Application No.: 10/034,580 Docket No.: 30014518-1

REMARKS

SYSTEM AND METHOD FOR INTERMEDIA AND COMMUNICATION WITH A MOVEABLE MEDIA LIBRARY UTILIZING A PLURALITY OF PARTITIONS REPLACEMENT SHEET - 10/034,580

FIG. 1

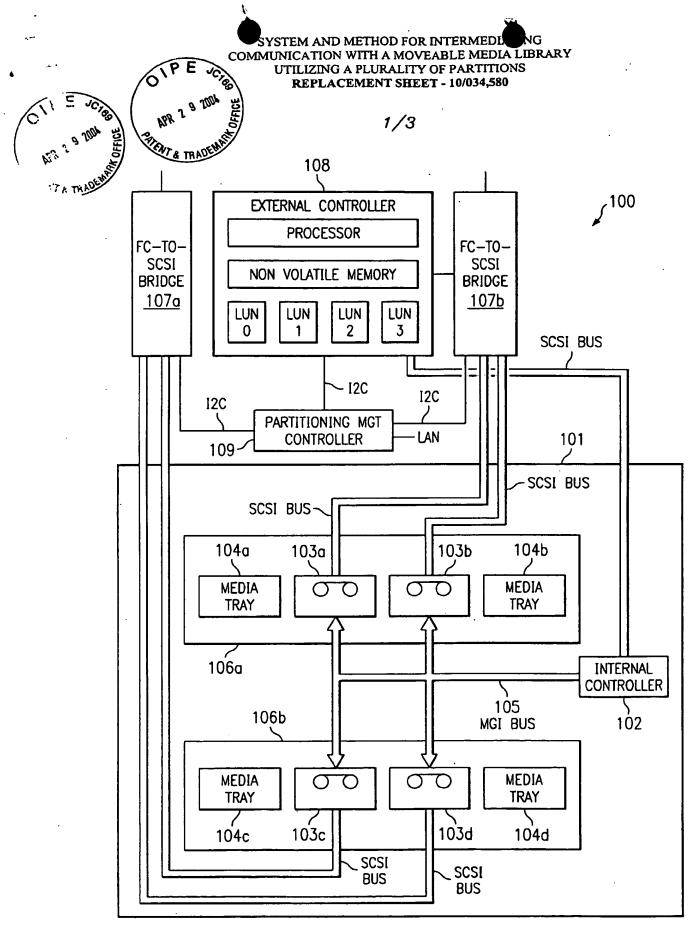
The Office Action dated May 22, 2003 contends that each of the labels TAP, LEVEL, SCSI BUS and MGI BUS "should be clearly incorporated with the corresponding element in the drawing by an arrow." Without conceding the contention of the May 22, 2003 Office Action, Applicants submit a replacement FIGURE 1 in answer to these objections. The erroneous label "TAP" has been deleted from FIGURE 1. The "LEVEL" labels have also been deleted, as the specification clearly indicates 106a and 106b are "levels" of the library shown in FIGURE 1. Thus, the "LEVEL" labels are not necessary in FIGURE 1. The labels "SCSI BUS" and "MGI BUS 105" have been given lead lines directed to the elements of FIGURE 1 to which they correspond.
